Final Environmental Impact Statement for the Buckman Water Diversion Project

Lead Agencies: USDA Forest Service and
USDOI Bureau of Land Management

Title and Location of Proposed Action: Buckman Water Diversion Project,
located in Santa Fe County, NM

Figure 2. Vicinity map.

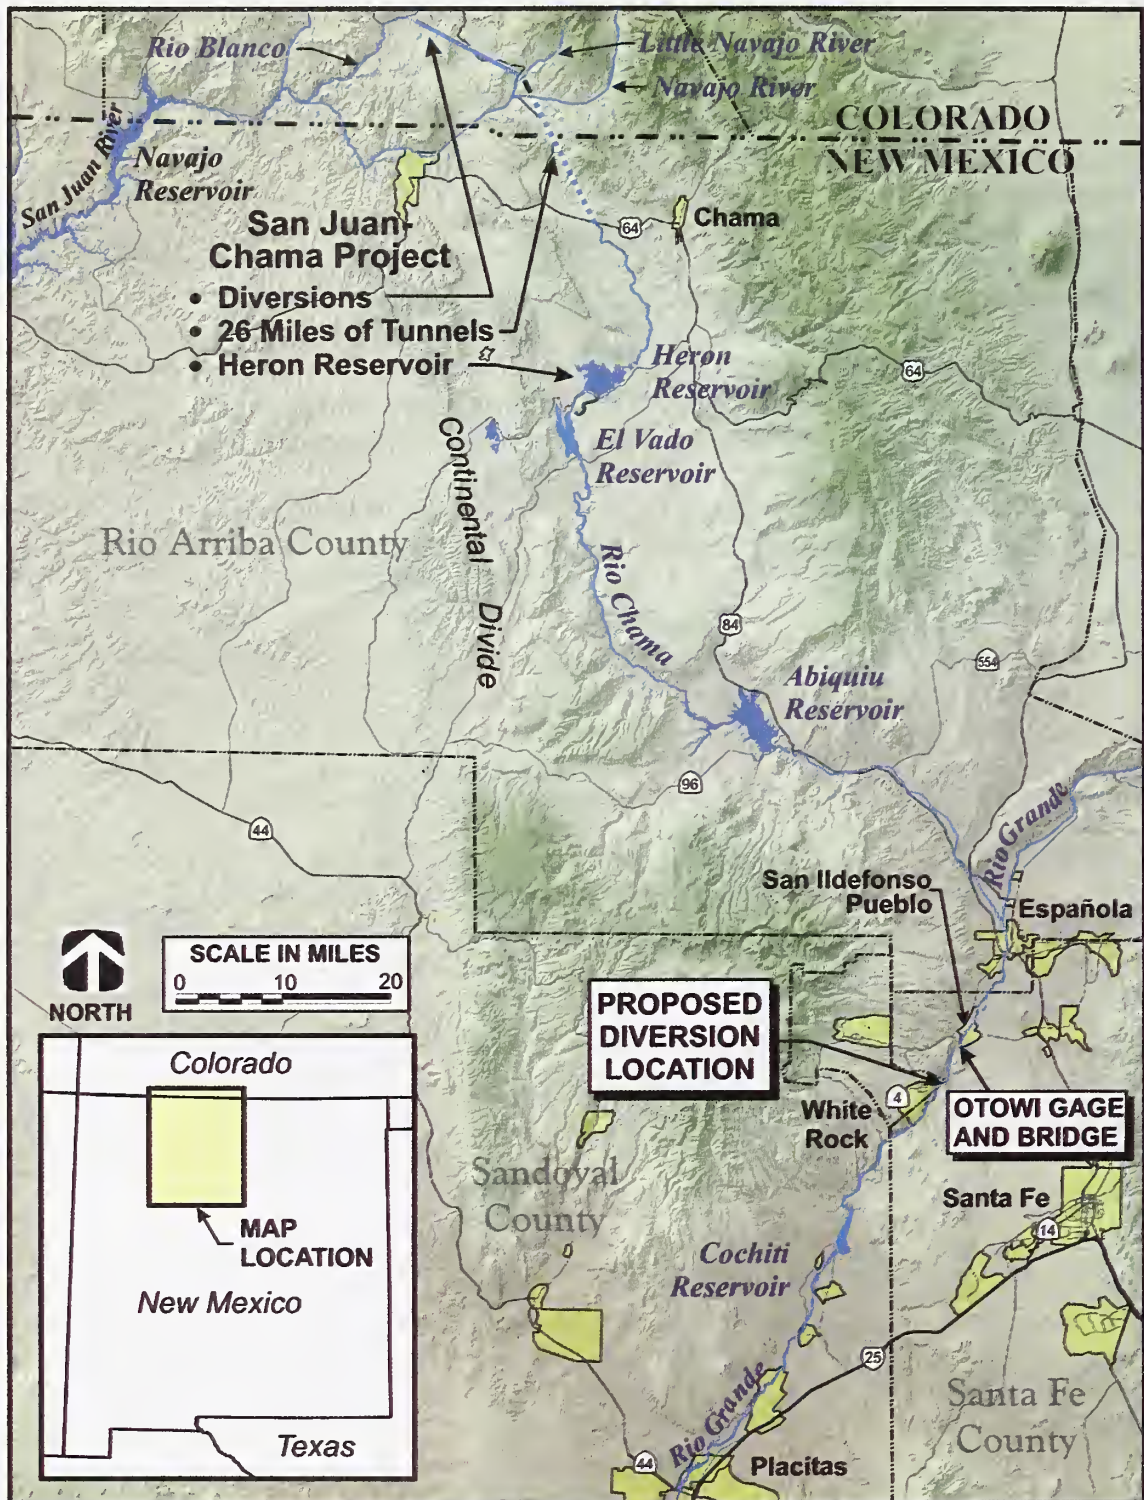
| 8. | At the scoping meeting and on the October 16, 2002 tour, we expressed our concern that LANL is not represented on the maps about the proposal. In fact, we were surprised to see on Figure 2 that the label "Proposed Diversion Location" covers the LANL site. p. 18 draft EIS. | } 5-12 |

- 5-11 Comment noted.
- 5-12 The location of Los Alamos National Laboratory has been added to Figure 1 (Draft EIS, page 8). In addition, Los Alamos National Laboratory has been added to Figure 2 (Draft EIS, page 18).

Figure 3. Location of water diversion, pipeline, and pumping facilities for the Proposed Action.

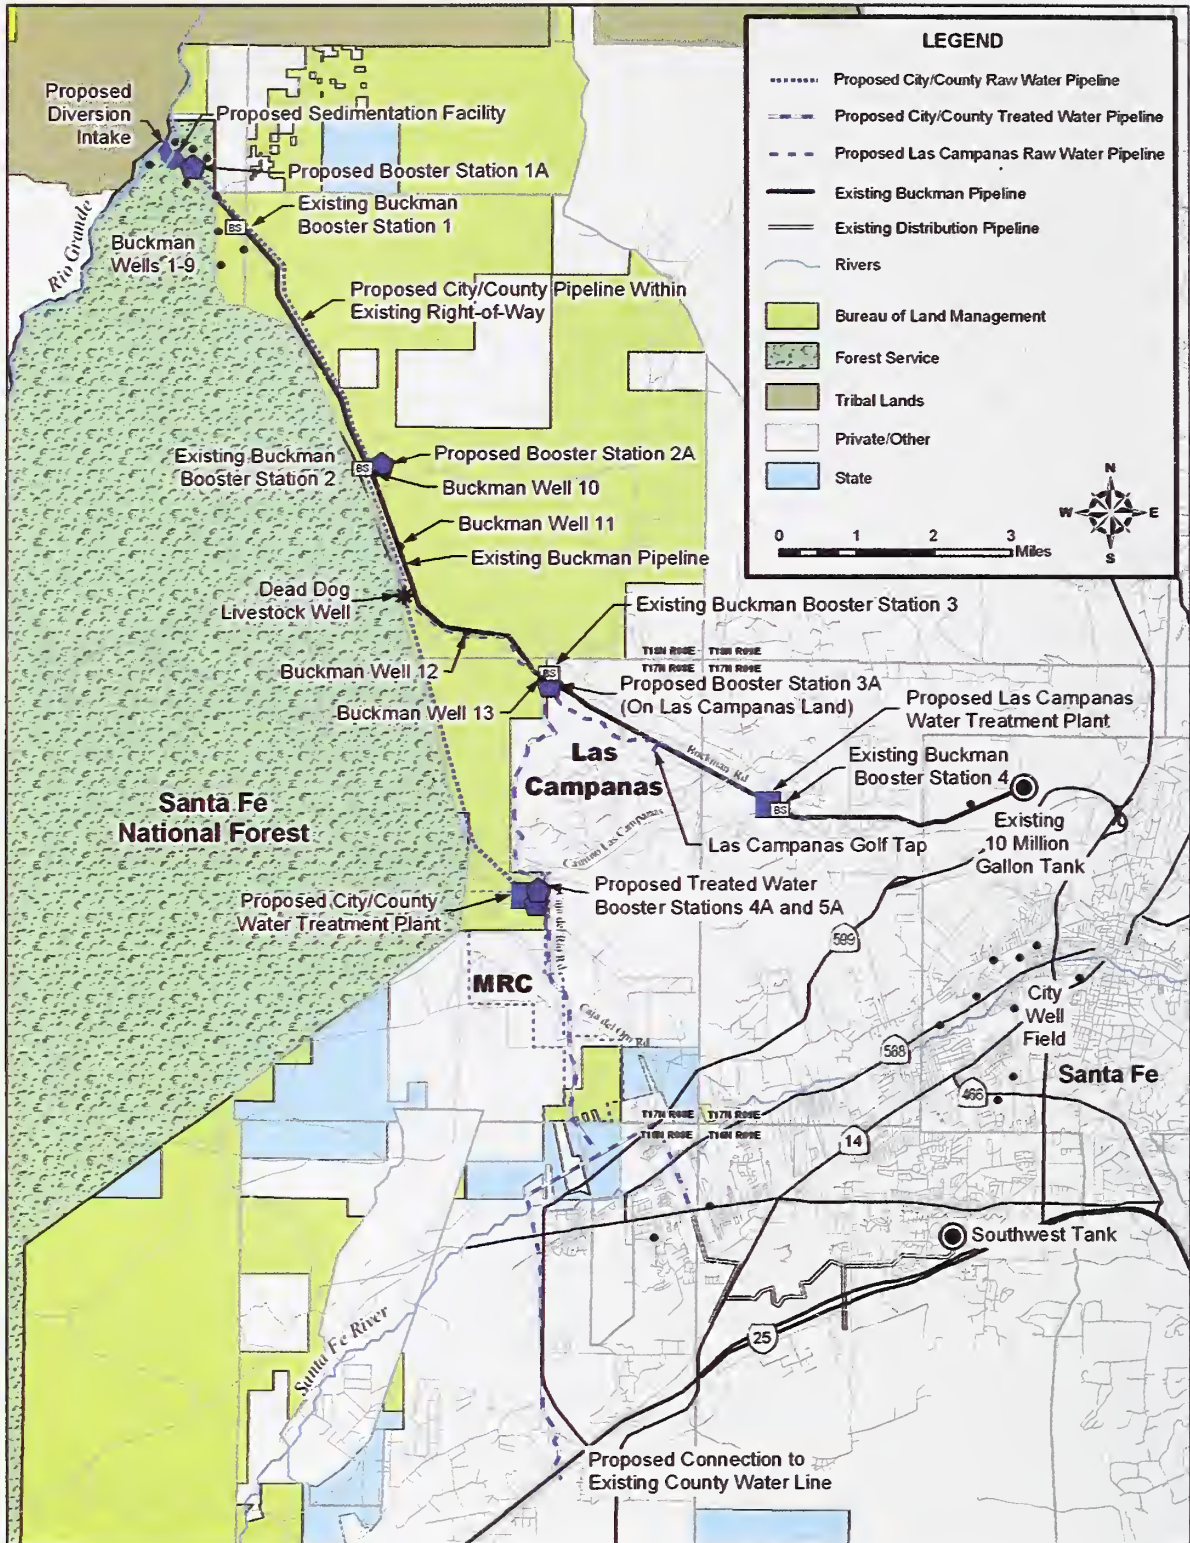
| 16. | We note in Figure 3 that the proposed City/County Treatment Water Pipeline terminates a little south of I-25. The final EIS should explain what it planned for that terminus. p. 20 draft EIS. | } 5-21 |

- 5-21 The text in Figure 3 on page 20 of the Draft EIS shows termination of the proposed City/County treated water pipeline as the proposed connection to the existing County water line. No additional changes will be required for the Final EIS.

Figure 19. Location of power upgrade facilities for Proposed Action and Alternative AGP1.

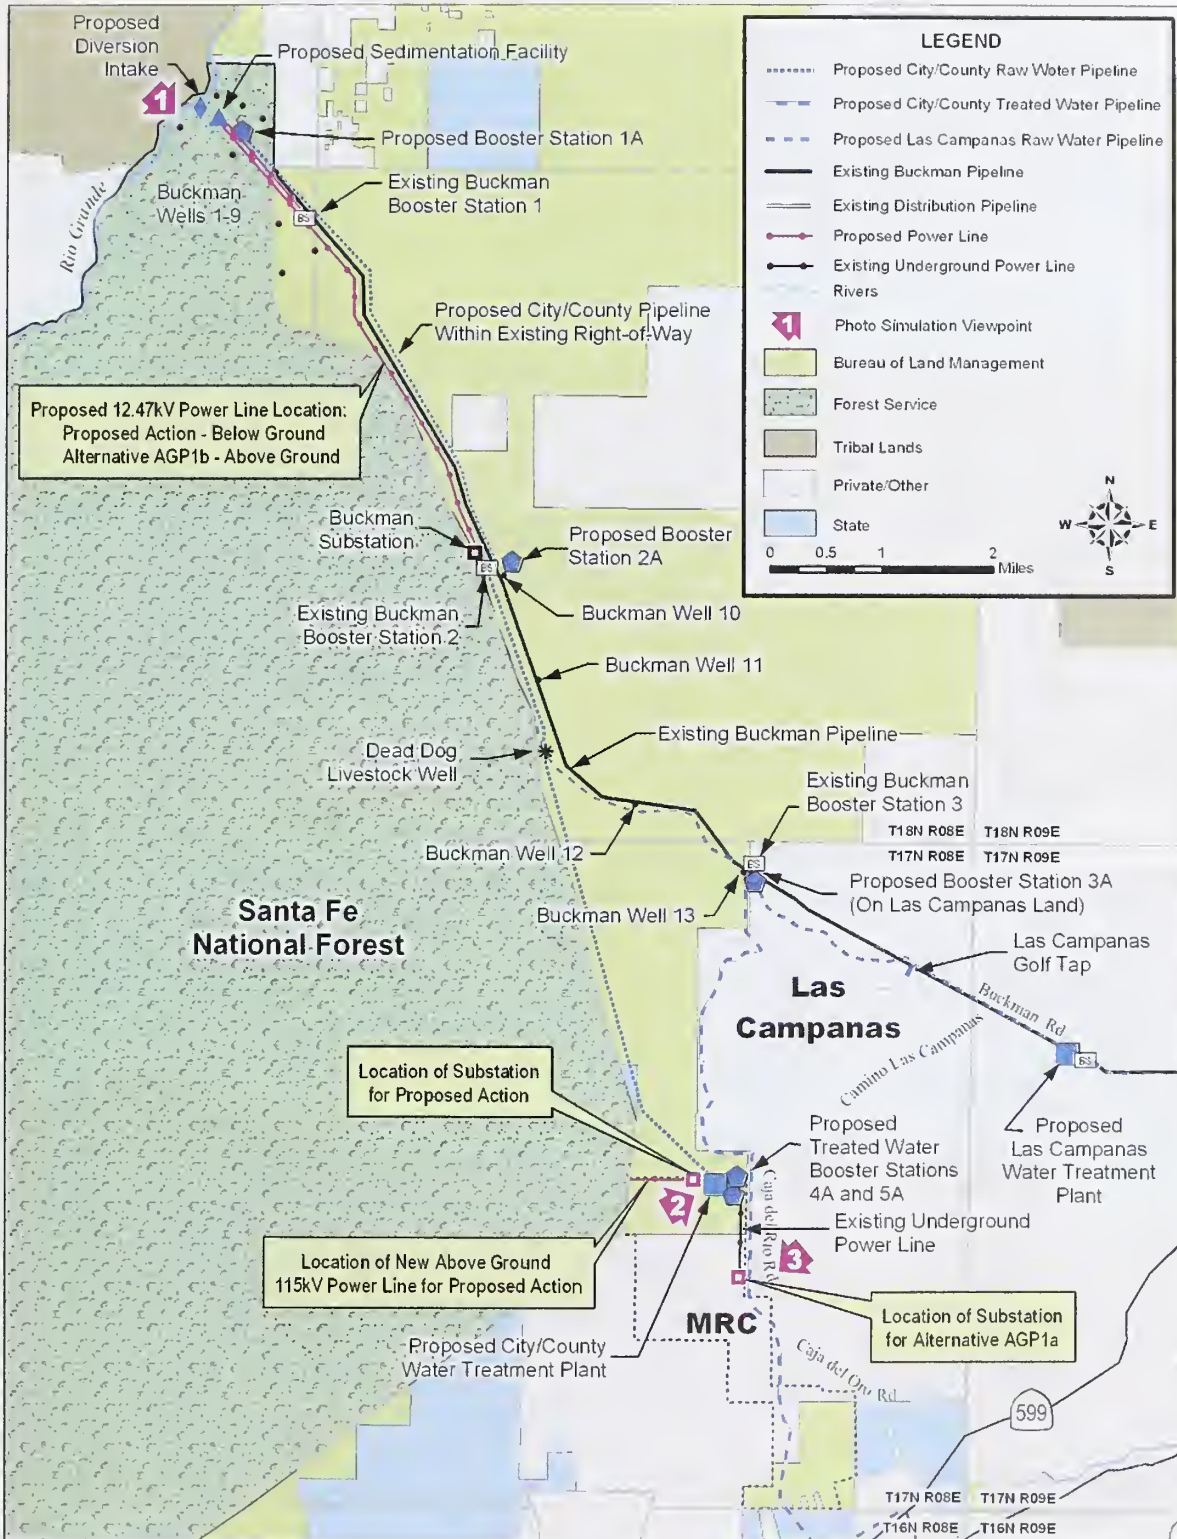
29. We were unable to distinguish the alternatives for the Treated Water Pipeline Alternatives in Figure 18 because the figure was printed in black and white. p. 57 draft EIS. We were also unable to distinguish the alternatives for the power upgrade facilities for the proposed action and	} 5-34

| alternative AGP1 in Figure 19 because it was printed in black and white. p. 60 draft EIS. We strongly urge the FS and BLM to print these figures in color in the final EIS. | } | 5-34

- 5-34 Figures 18, Treated Water Pipeline Alternatives and Figure 19, Location of Power Upgrade Facilities for Proposed Action and Alternative AGPI will be printed in color in the Final EIS.
